ORIGINATION FORM

Proposed Revisions to a Standard Plans Index
(Please provide all information — Incomplete forms will be returned)

Index Number: 450-010

Index Title: Florida I Beam - Typical Details and Notes

INDEX
450-010

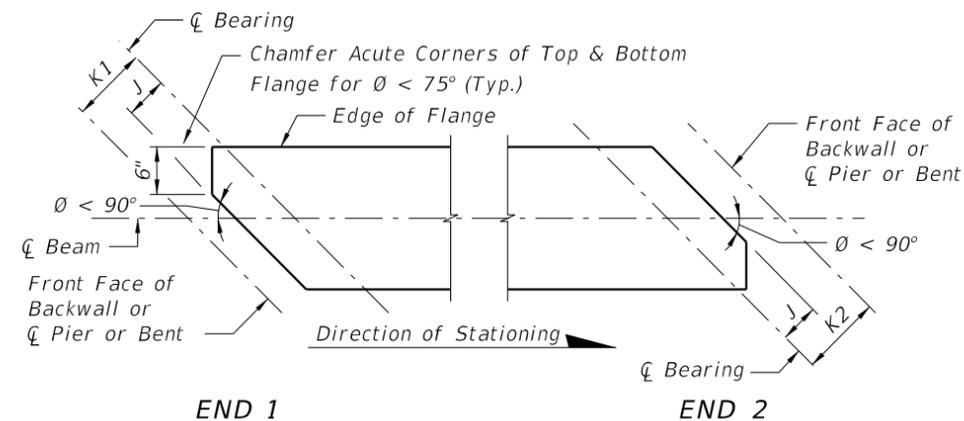
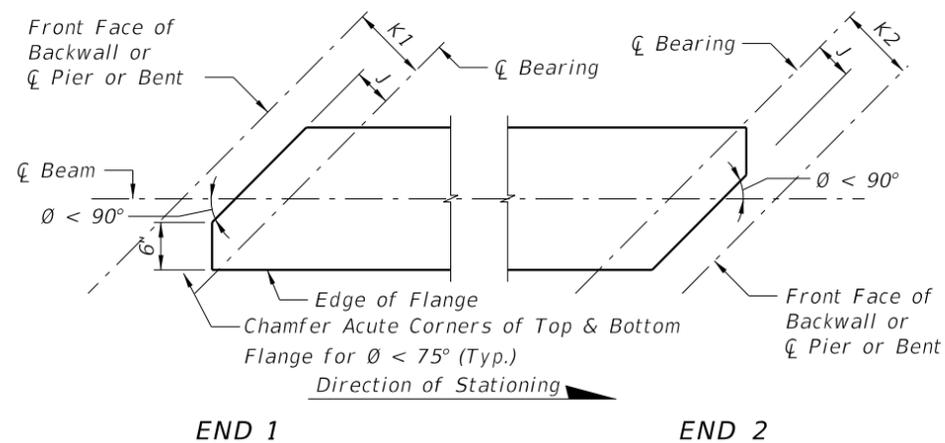
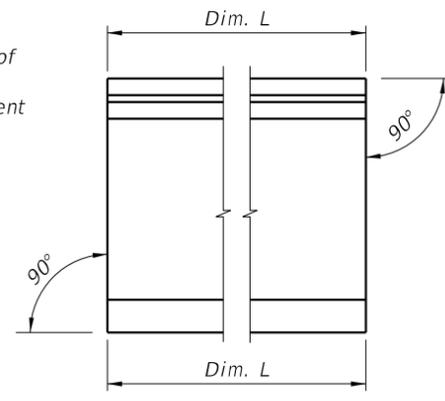
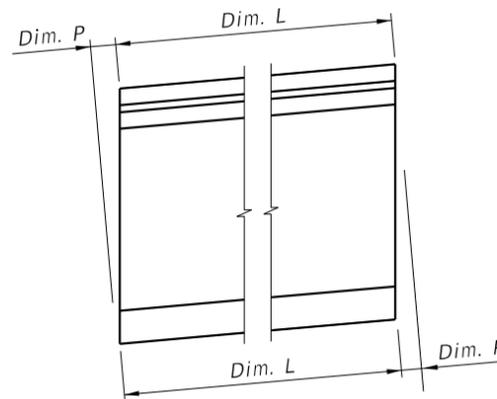
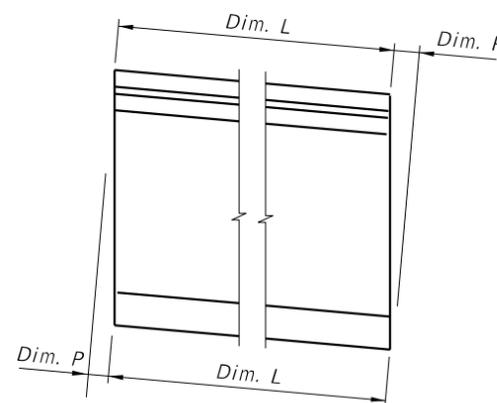
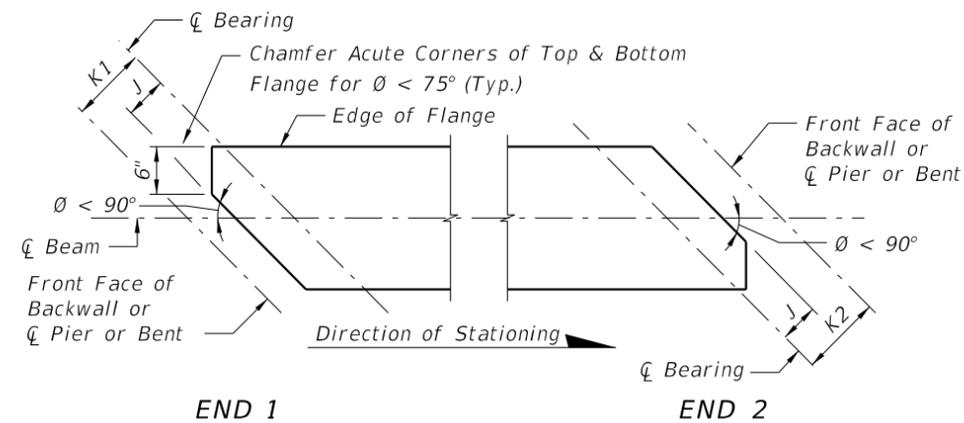
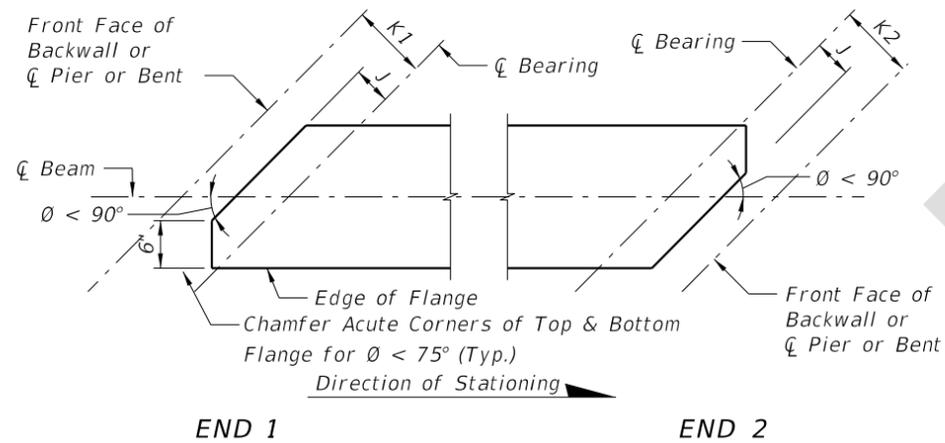
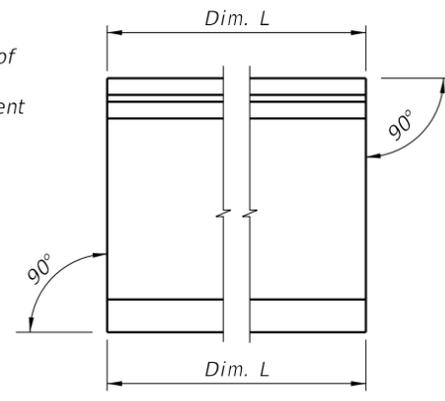
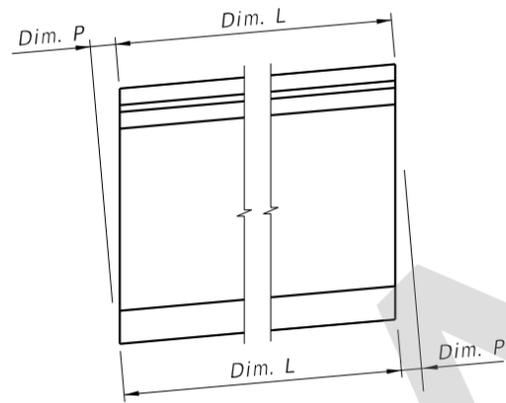
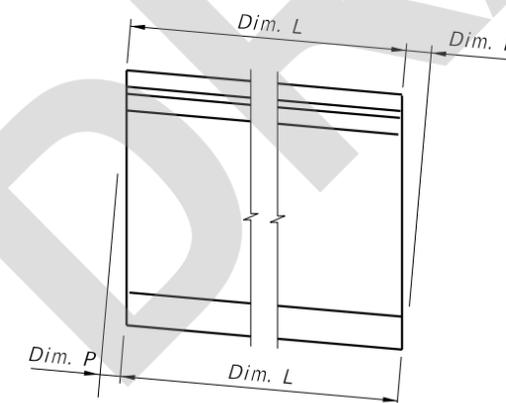
Updated language concerning N type strands in the notes for clarity.

3. Concrete cover: 2 inches minimum.
4. ~~Stress Strands N to 10 kips~~
~~Stands N: 3/8" diameter, stressed to 10,000 lbs. each.~~
5. Place one (1) Bar 5K or 5Z at each location. Alternate the direction of the ends for each bar (see "ELEVATION AT END OF BEAM" in Standard Details).

- Concrete cover: 2 inches minimum.
- Stress Strands N to 10 kips each.
- Place one (1) Bar 5K or 5Z at each location. Alternate the direction of the ends for each bar (see "ELEVATION AT END OF BEAM" in Standard Details).
